REPLACING PAGE ADDENDUM

**PANEL SELECTOR COMMUTATORS
AND COMMUTATOR BRUSHES
REQUIREMENTS AND ADJUSTING PROCEDURES**

1.001 This addendum supplements Section 026-120-701, Issue 5. The attached pages must be inserted in the section in accordance with the filing instructions above.

1.002 This addendum is reissued to revise Part 2 and Part 3.

Fig. 66, 67, 68, 69—Subscribers Link Frames (No. 6A Commutator 22 Terminal District Finder)

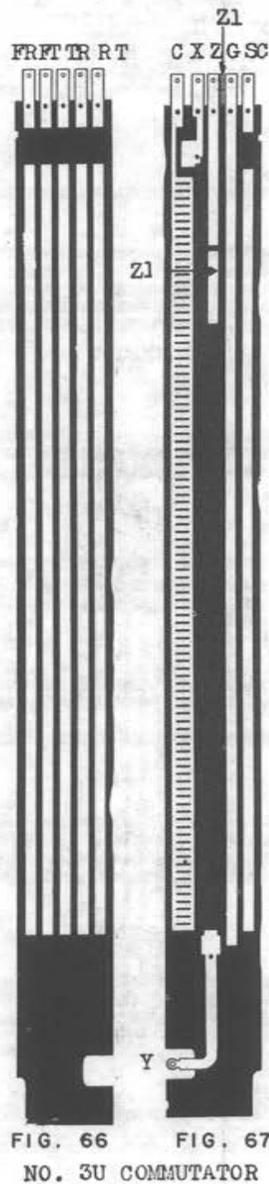
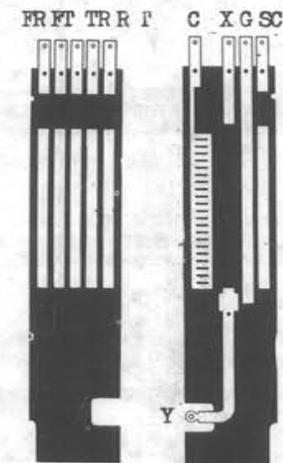
(c) Fig. 66, 67, 68, 69, 70, and 71 to show revised limits of adjustments of C commutator spring.
